Twins Carwash
Site Plan - Design Review
5340 S. US Highway 1

Request for review of an application for a Site Plan (Development and Design Review) to construct a 4,930 square-foot automated carwash with self-service vacuums.

Subject: Site Plan – 5340 S. US Highway 1 – Technical Review Committee Comments for January 19, 2023 TRC Meeting

RE: Twin's Car Wash - Ft Pierce – 3rd Site Plan Review Resubmittal
1-TRC NO. 23-20000306
Parcel: 3403-433-0008-000-2
Address: 5340 S. US Hwy. 1, Fort Pierce, FL 34982
Engineer's Project No. 22-017

ELEVATION
 VACUUM/DUMPSTER ENCLOSURE

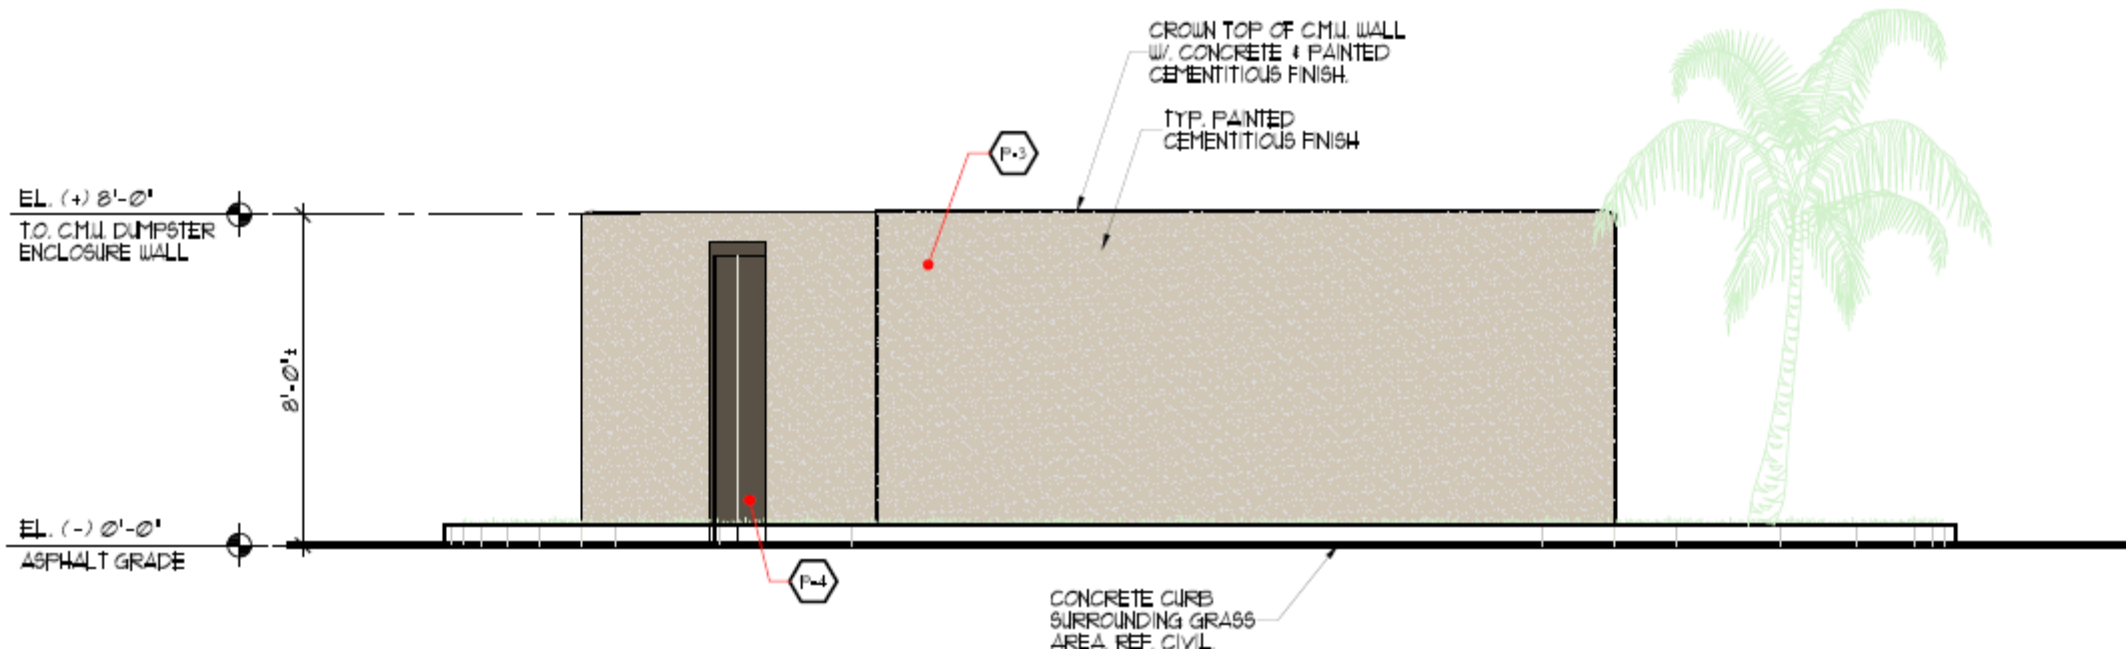
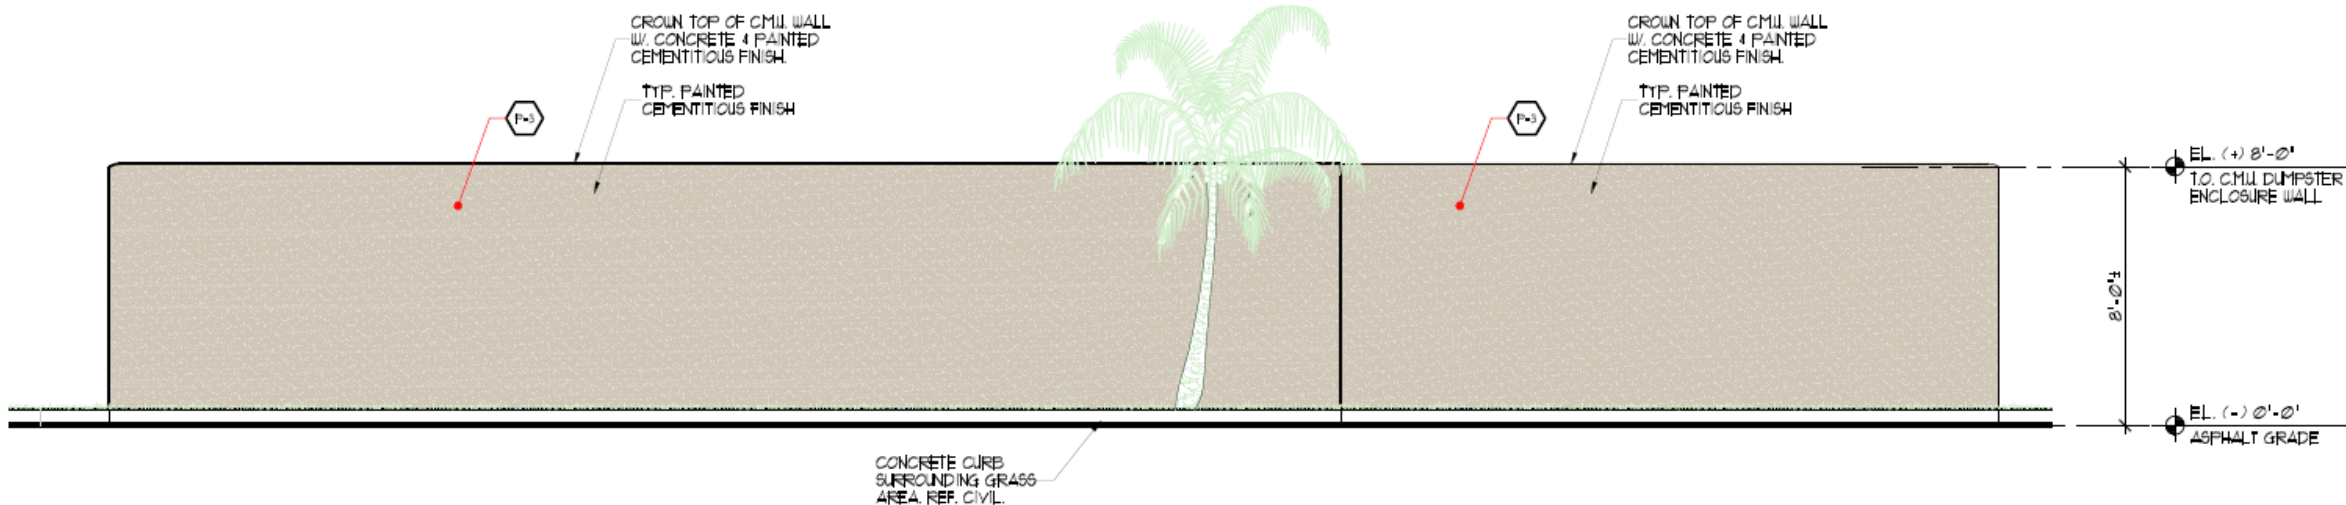
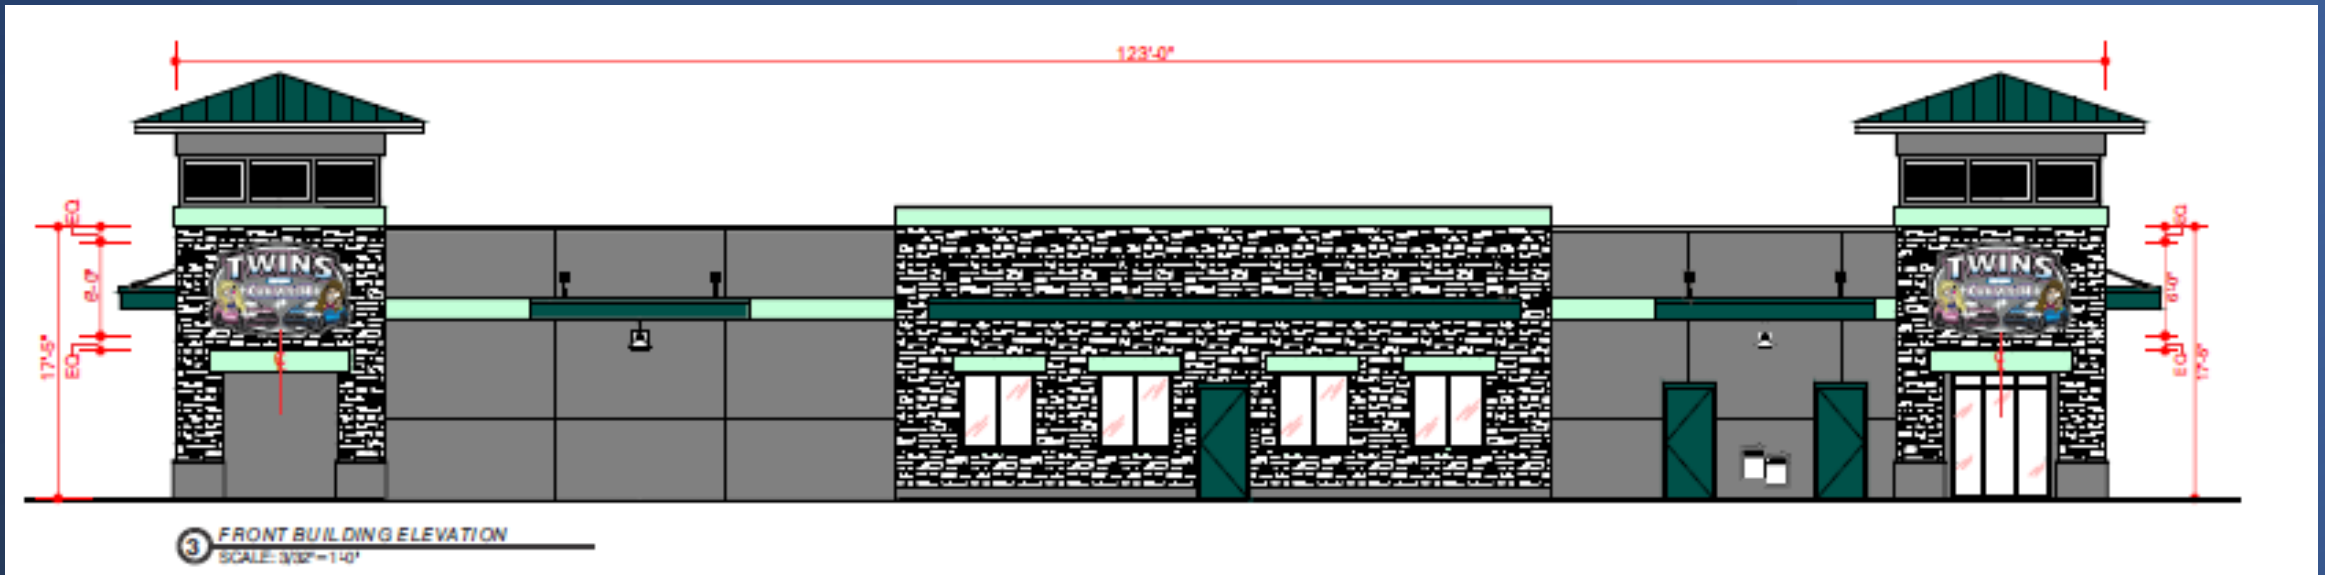
2. Relocate the dumpster and enclosure from the entrance of the site in accordance with the City of Fort Pierce Code of Ordinance Section 123-37(10)

PLEASE NOTE THAT THIS WAS RESOLVED PER OUR EMAIL DISCUSSIONS. PLEASE SEE ATATCHED RENDERINGS AND ELEVATIONS.
